FLORENCE PLANNING COMMISSION ITEM UPDATE/SUMMARY

TOPIC: Cannery Station Final PUD, Tentative Subdivision, Design Review

Memo Date: June 18, 2013
Meeting Date: June 25, 2013
Staff Contact: Jacob Callister
Contact Telephone Number: 541-682-4114

SUBJECT: CANNERY STATION
RESOLUTION PC 12 12 FPUD 01, PC 12 13 SUB 01, PC 12 14 DR 01

A1.1

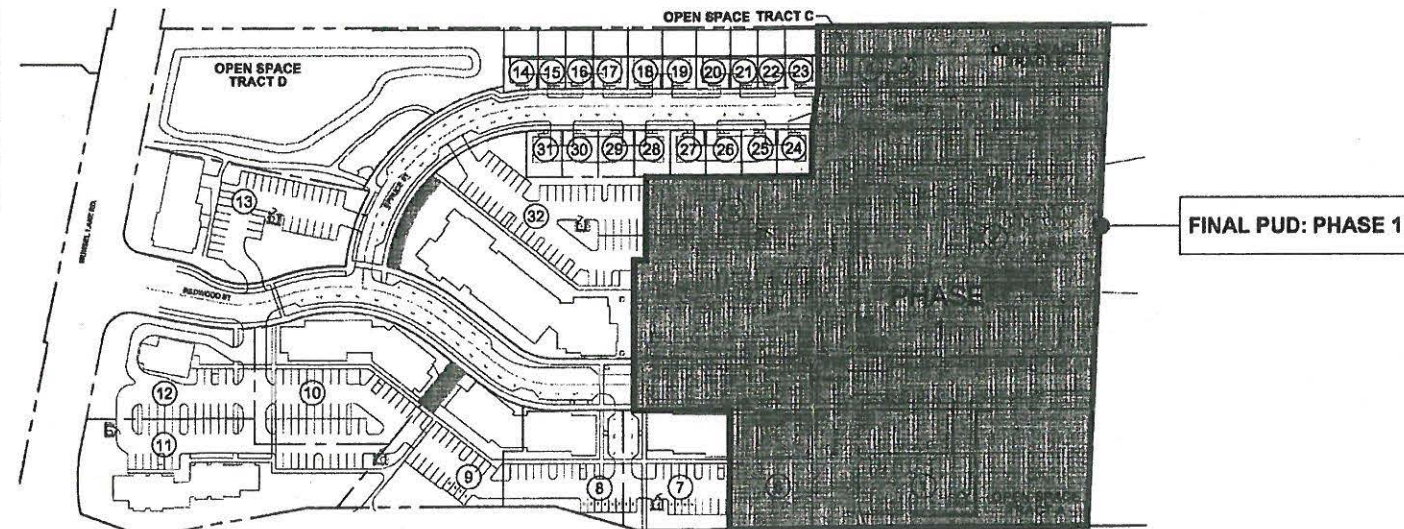
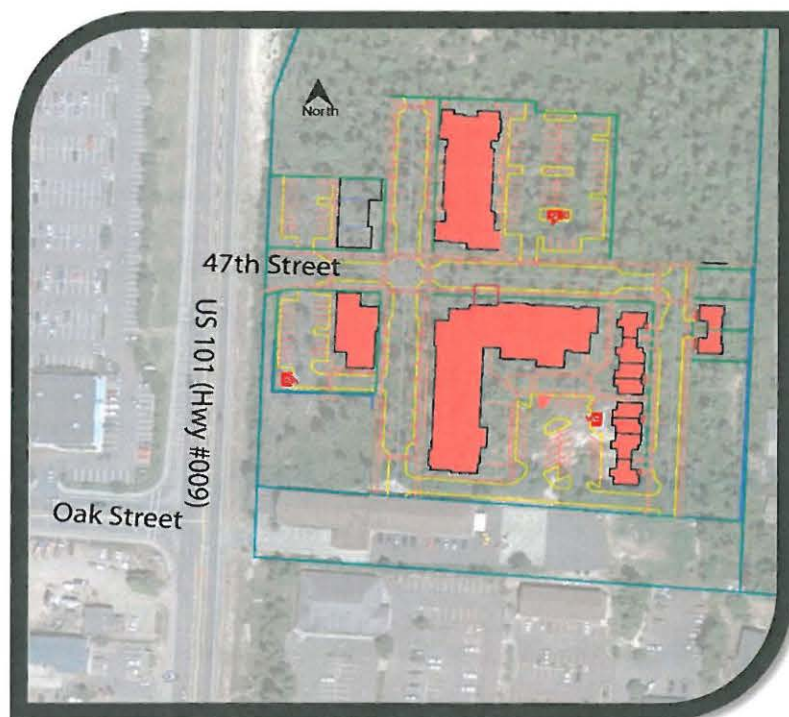
2. Parking Summary. As part of Exhibit 15 Sheet A1.1 Land Use Plan, the applicant provided a parking summary which outlined the parking that will be required for variable structure sizes that may accommodate the lots of Phase 1. This table contained some errors and needed to be updated. The applicant has provided the revised parking table in a revised Sheet A1.1 which is attached as Exhibit 15.

Phase 1 Final PUD, Sheet A1.1 had a table listing the number of parking spaces required and provided on a lot by lot basis. Some of the parking figures were inaccurate so the table was updated. Please refer to Attachment C – Revised Sheet A1.1.

Regarding parking aisle widths, we would like to propose a consistent aisle width of 24 feet. The parking lot aisle width in Lot 6, therefore, would be changed to 24 feet.

Exhibit 7-2 Right Turn Lane Criterion

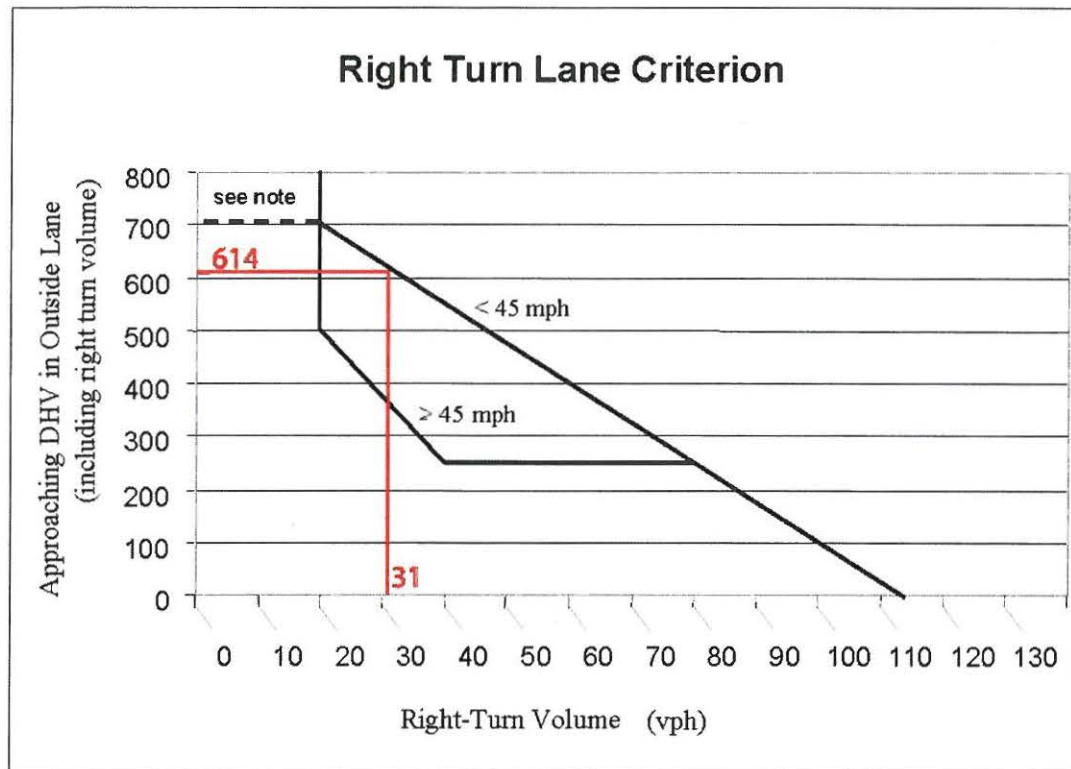
The traffic volumes entering 47th Street were evaluated to determine if a northbound right turn lane is required. ODOT provides criteria within the *Analysis Procedures Manual* in which a right turn lane should be considered for installation. The right turn lane criteria was evaluated for Year 2014 conditions under full-build out of the site. The criteria evaluates traffic volumes on the mainline in the through direction and compares them to the right turning volumes and the roadway speed. Under the year 2014 pm peak hour conditions, the mainline traffic volume is projected at 614 and the right turn volume is projected at 31 vehicle. The evaluation is summarized on the graph below.

The *Analysis Procedures Manual* states, "meeting the criteria does not require a turn lane to be installed". As shown the traffic volumes border on the threshold for meeting the criteria for a right-turn lane. It would appear that there would have to be additional reasoning to install a right turn lane for this phase of development. The traffic volumes to the site are not sufficient enough to require the installation of a right turn lane into the site. Given the urban nature of Highway 101 there is not an unexpectancy of right turn vehicles exiting Highway 101. As there are many other locations for right turn movements from Highway 101 within a half mile north and south of 47th Street, motorists are aware of turning movements into and off of Highway 101.
